## PreBid RFI Responses

<b>Date</b>	January 31, 2014	<b>Subject</b>	Pre-Bid RFI Responses
<b>Project</b>	VA Salisbury - Bldg 42 Phase III		
<b>Project No</b>	09-0005.03	<b>Prepared By</b>	Frank Freeman

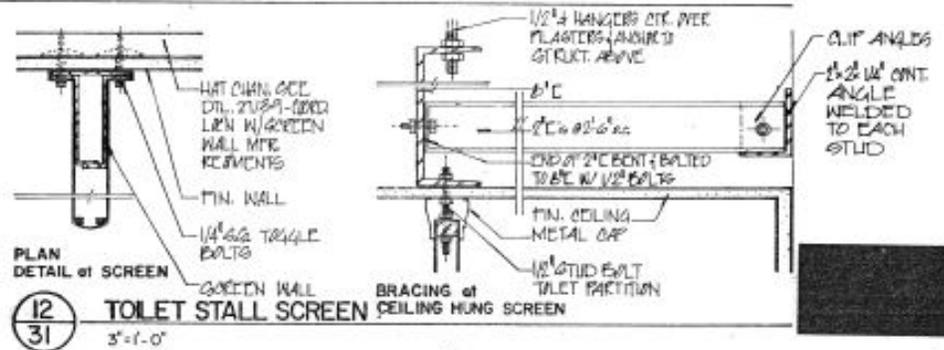
7. It appears that the toilet partitions in all large common bathroom are suspended above ceiling. Please confirm if structural steel is supporting it. If so, does this steel need to be removed? Contractors not able to verify due to denied access.

**Response:** Existing document details the bracing at the ceiling hung partition as a system of channels suspended by rods to the structure above. See diagram below.
